PROJECT THE WORLD TRADE CENTER | TITLE PLAZA LEVEL SECTIONS K-1 | DATE 10-7-71

19-K-1047.1

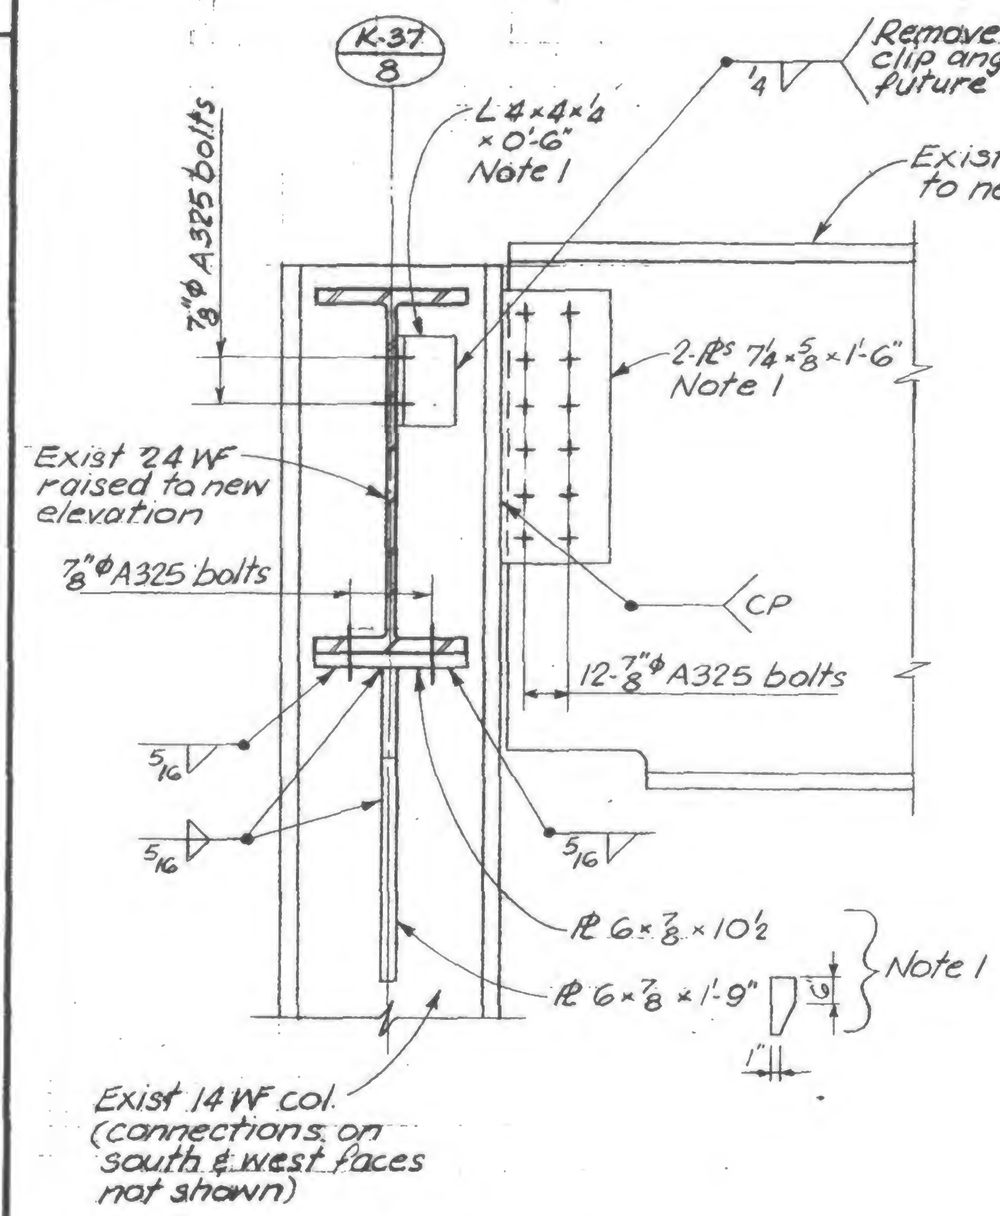
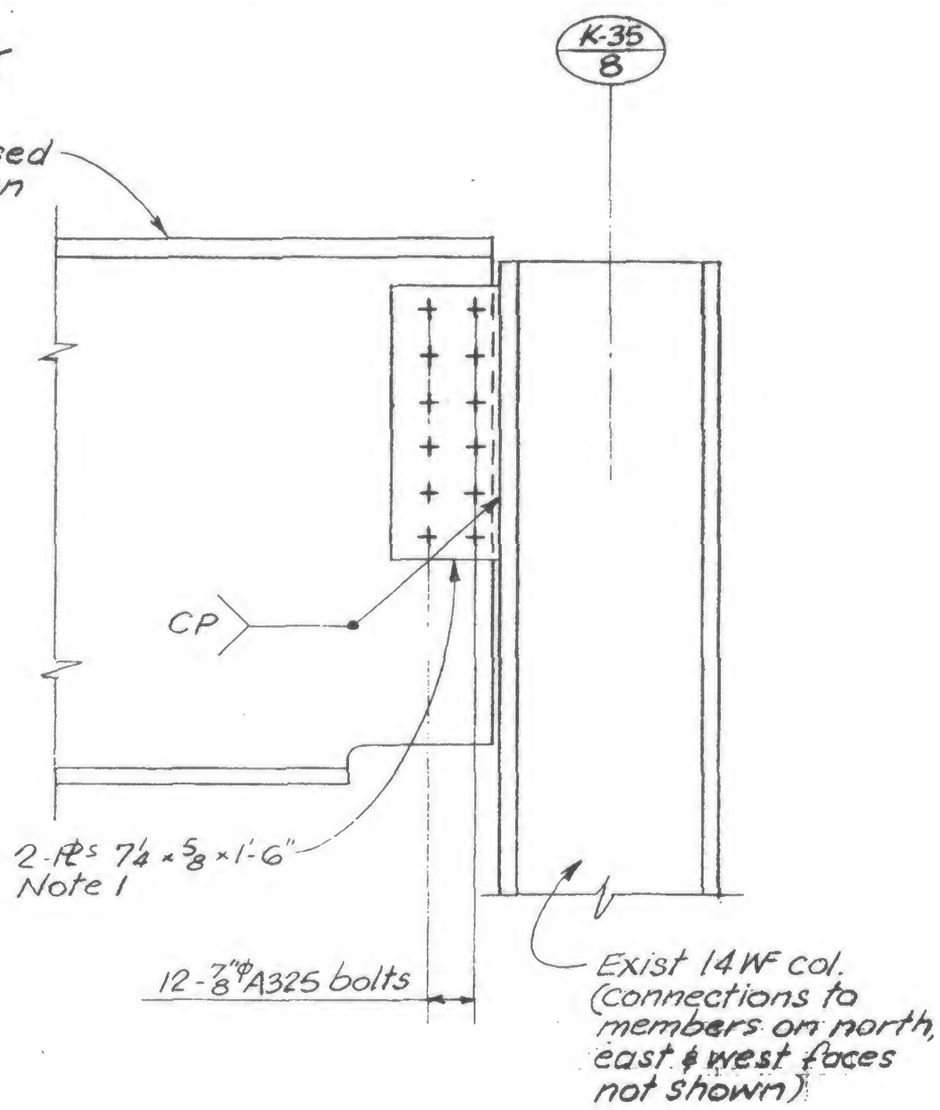
Note 1: Remove existing connection and reuse material in new location if in satisfactory condition. Bolts must be new material.
